ADDENDUM NO. 1

PROJECT NUMBER: 0042-0324
 PROJECT DESCRIPTION: EAST HARTFORD MAINTENANCE FACILITY AND SIGNS AND MARKING FACILITY
 TOWN(S): EAST HARTFORD
 DRAWING TITLE: PANEL SCHEDULES 2

PROJECT NUMBER: 0042-0324
 PROJECT DESCRIPTION: EAST HARTFORD MAINTENANCE FACILITY AND SIGNS AND MARKING FACILITY
 TOWN(S): EAST HARTFORD
 DRAWING TITLE: FUEL ISLAND CONDUIT PLAN

DRAWING NO. EM-600
 SHEET NO. 06F.24.A1

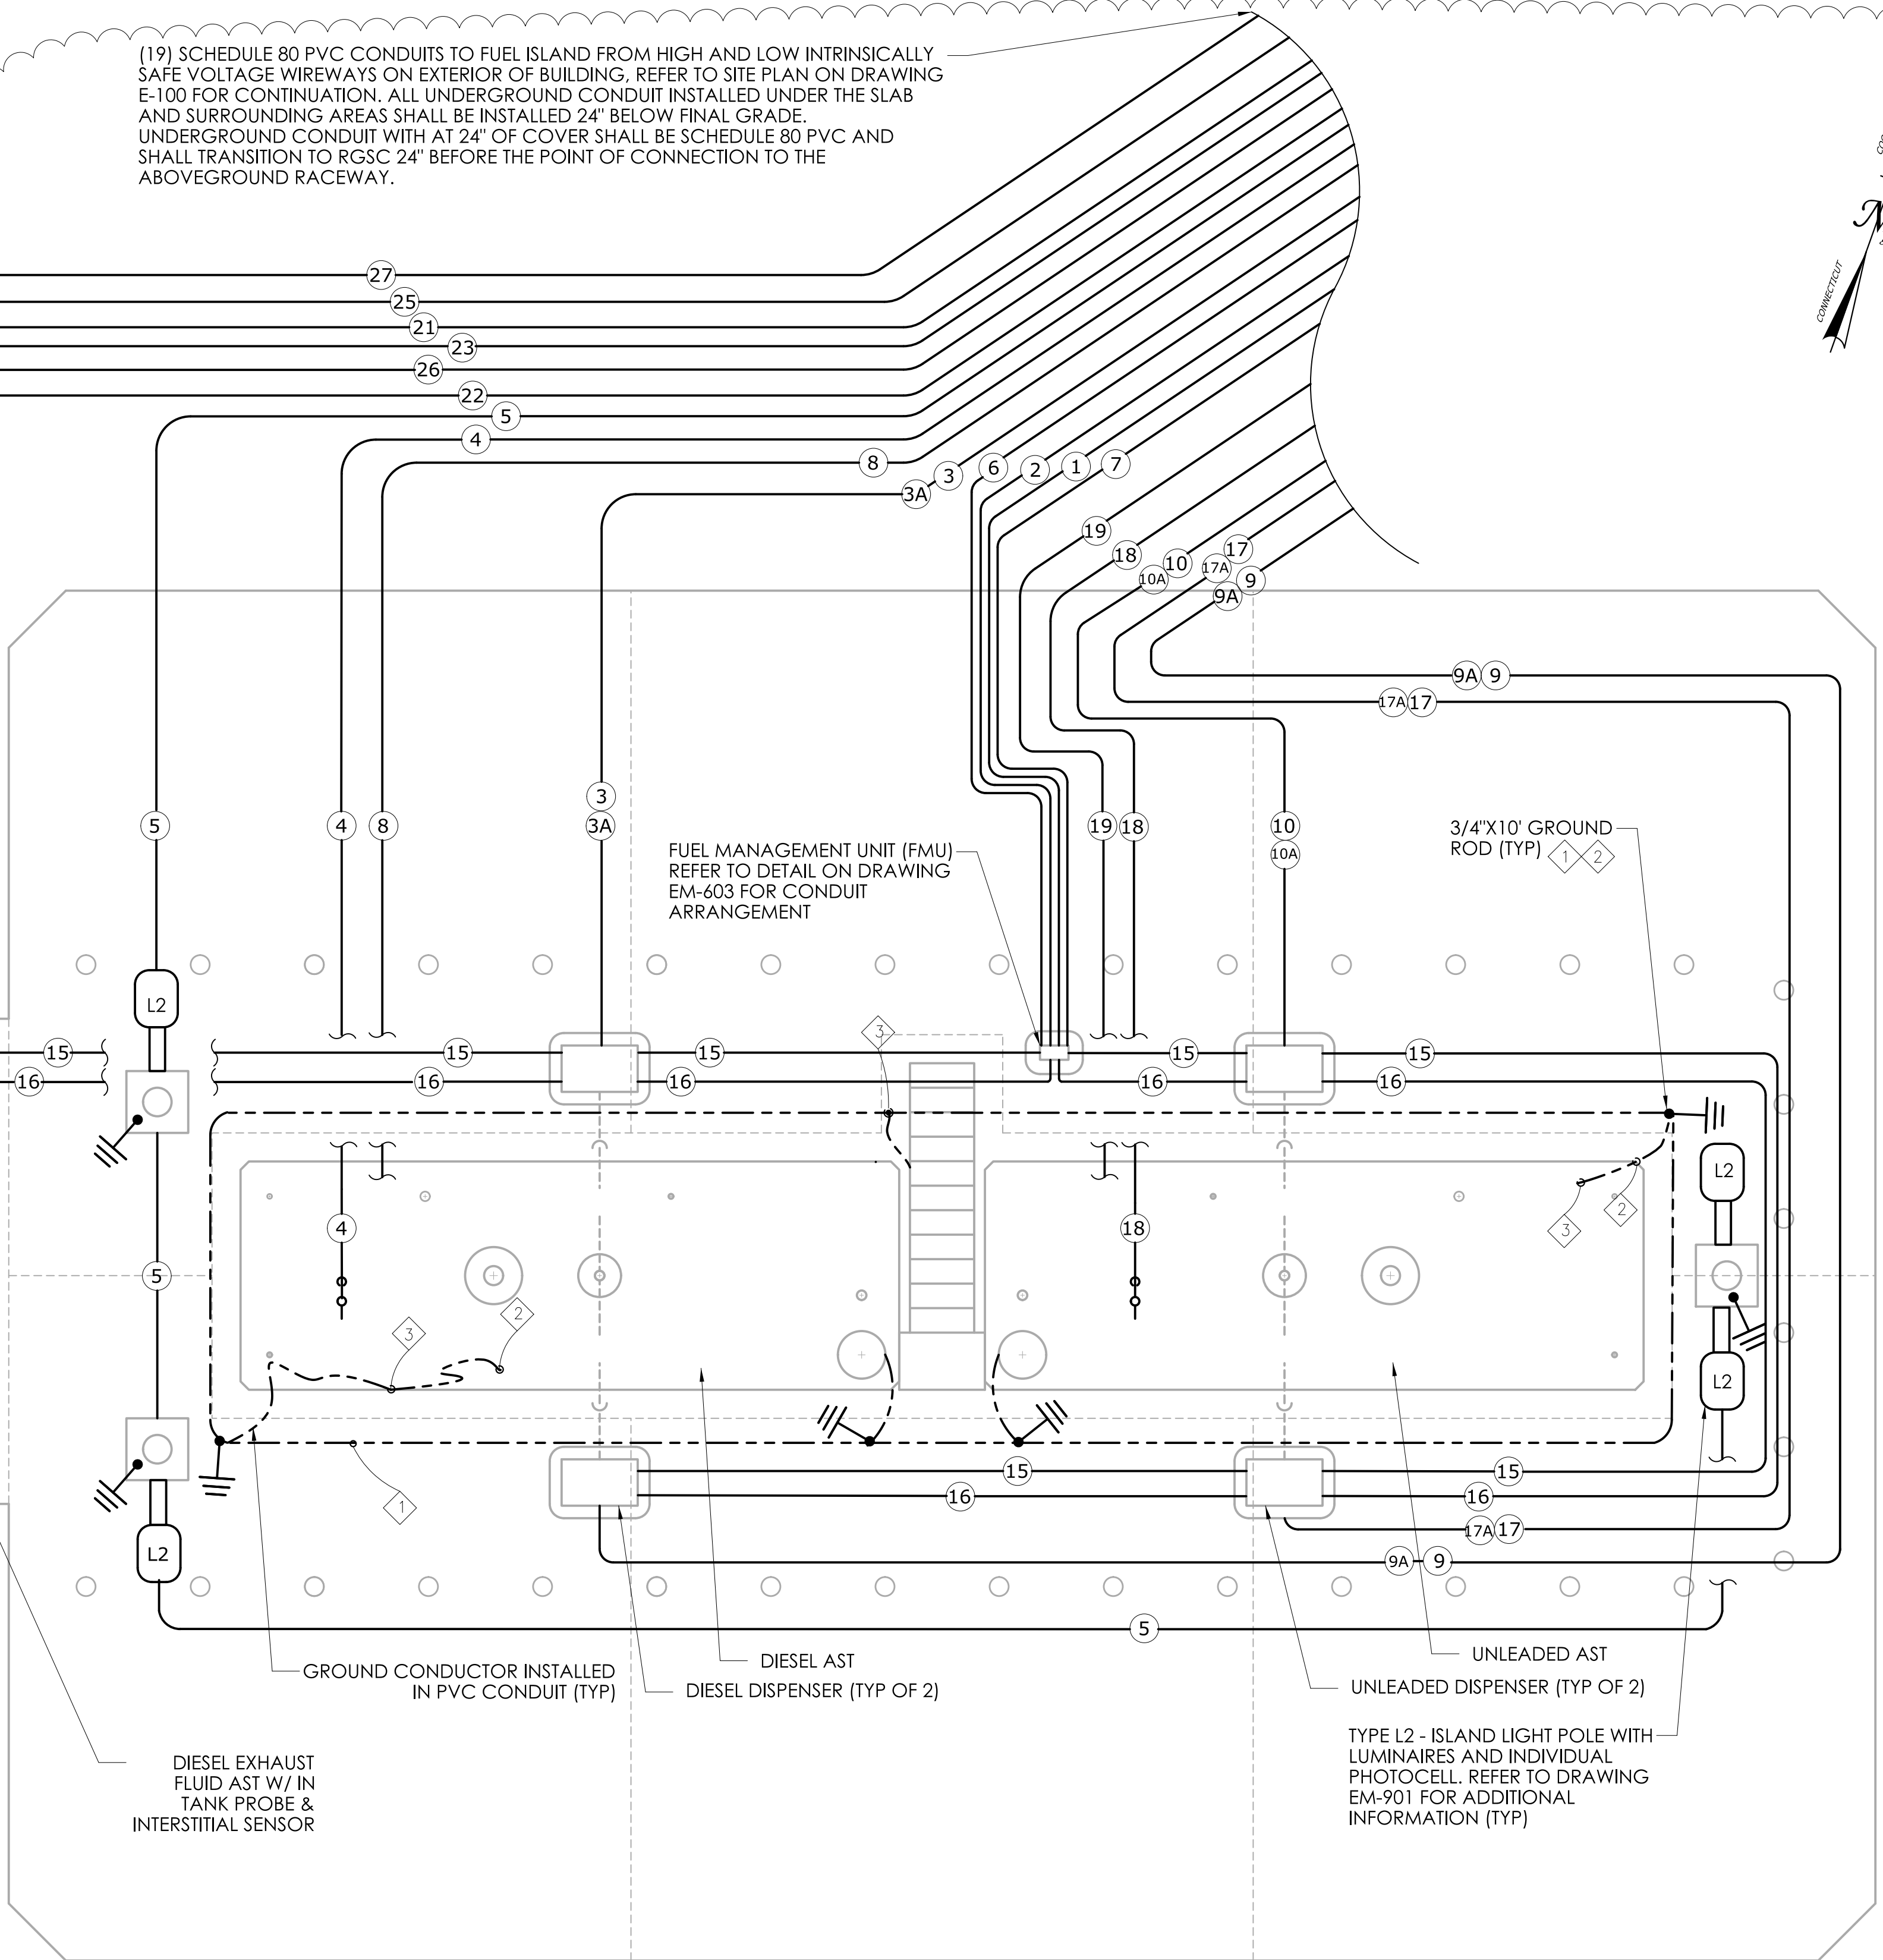
REV	DATE	DESCRIPTION
5/11/22		MIRRORED ELECTRICAL ROUTES
